City of Albuquerque

RE: ENGINEER'S CERTIFICATION OF ACADEMY OFFICE PARK,
EROSION CONTROL PLAN, RECEIVED JUNE 1, 1988 FOR
CERTIFICATE OF OCCUPANCY APPROVAL (E-18/D17)

D R A I N A G E R E P O R T

A C A D E M Y A C R E S

BASIN A ✓

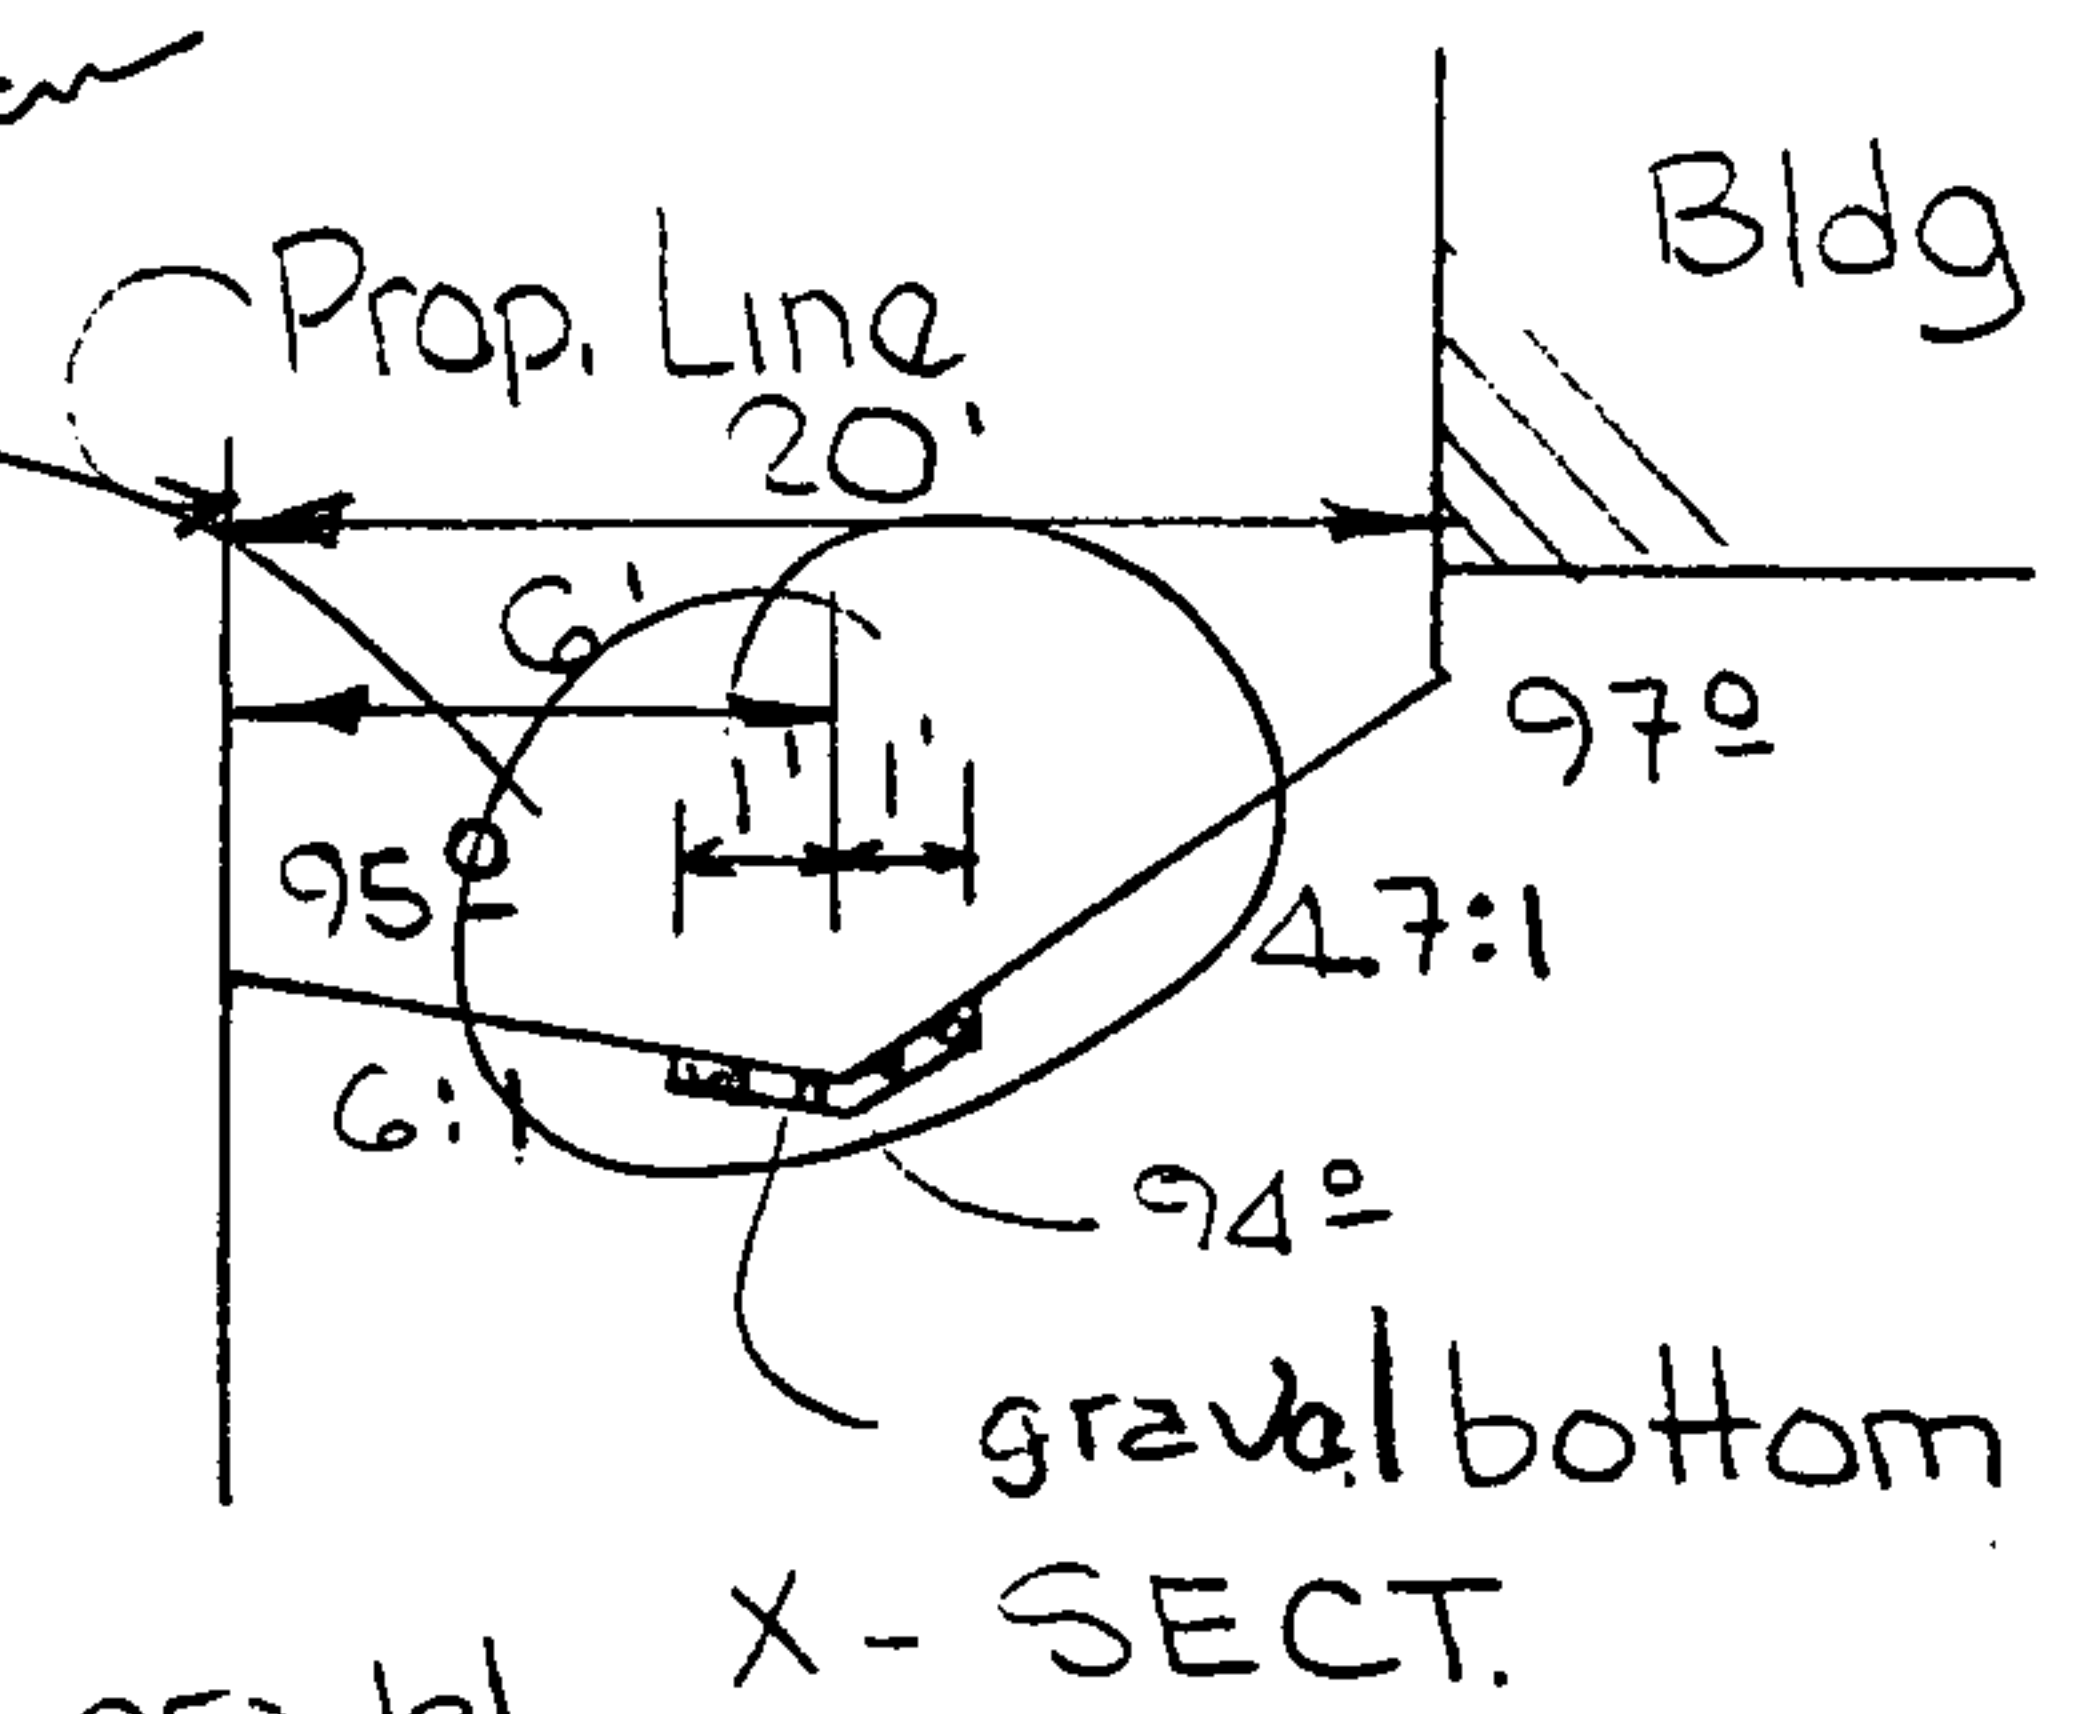
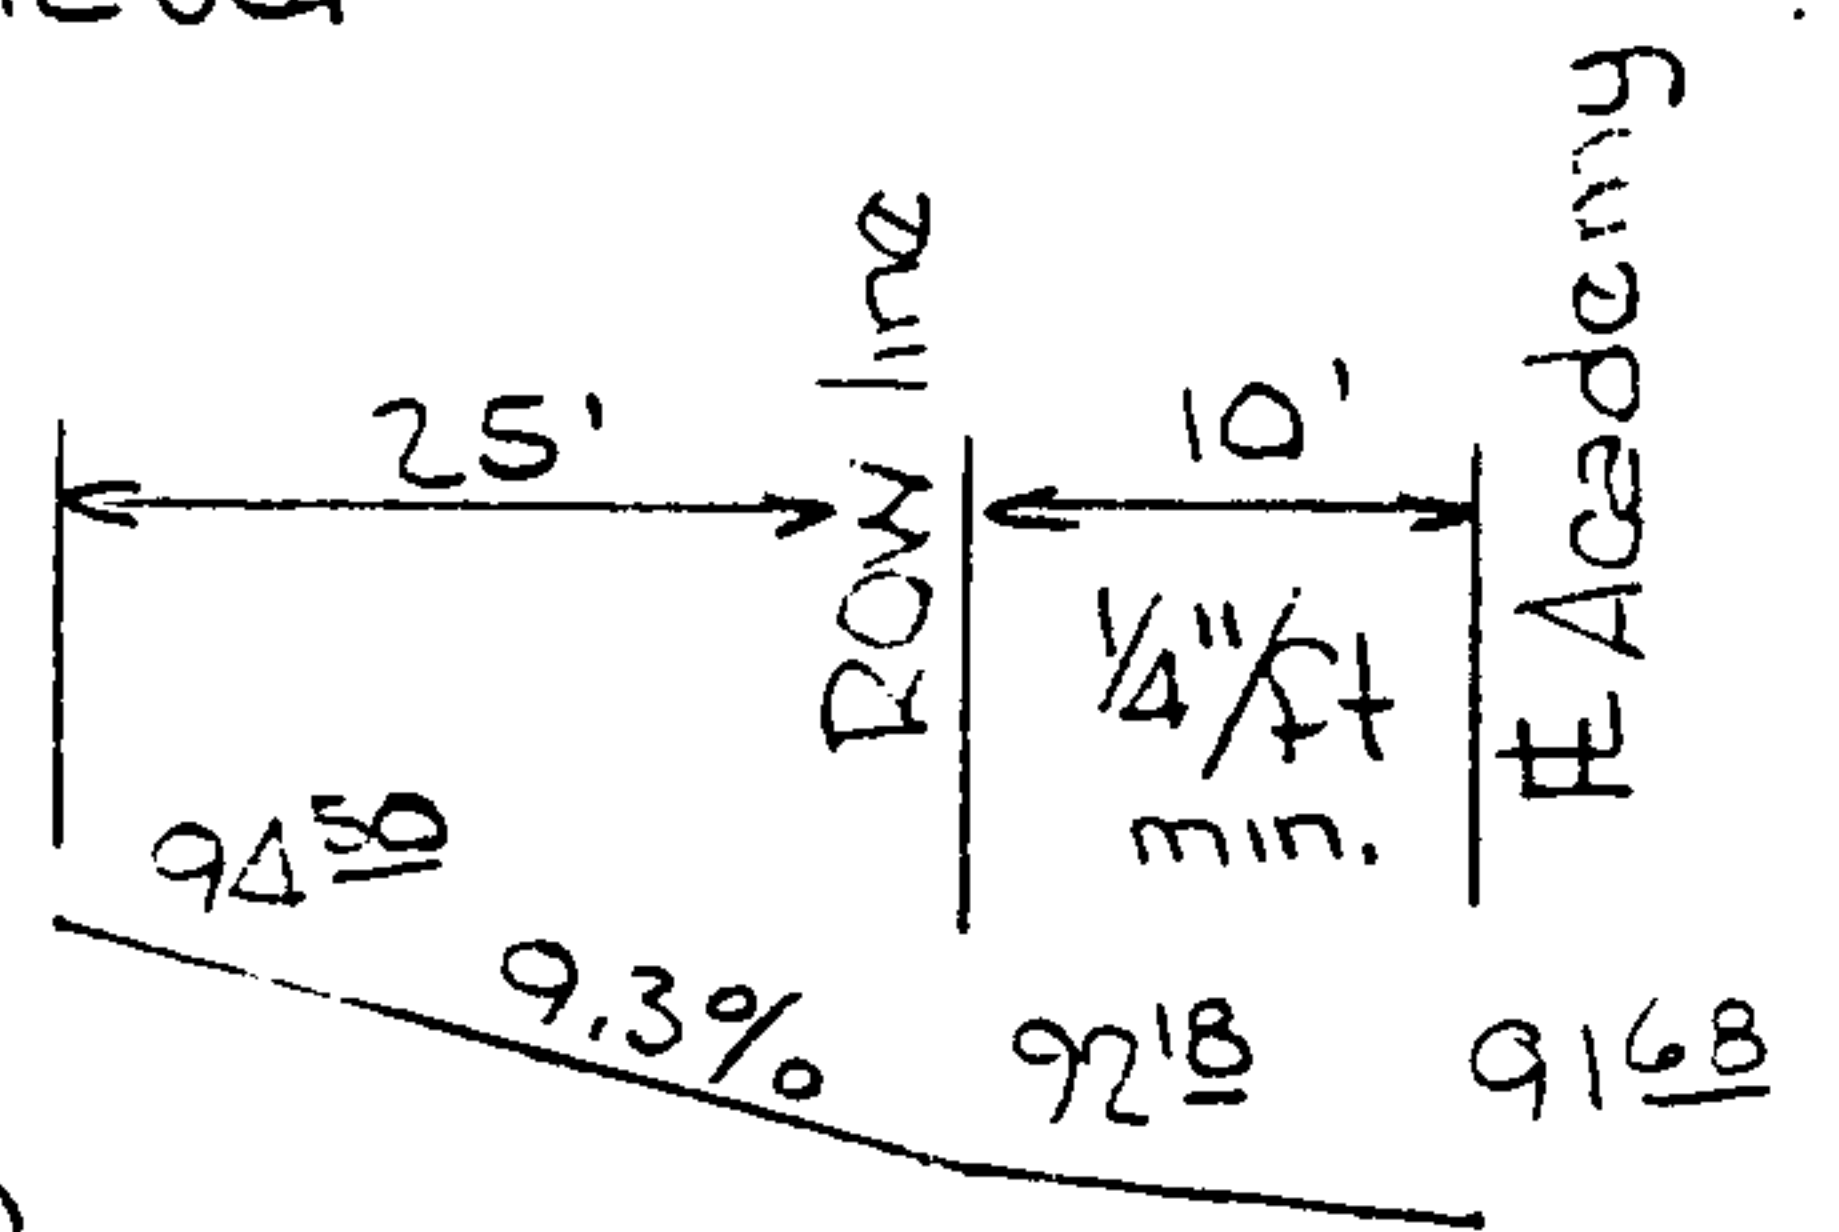
18" concrete on plan
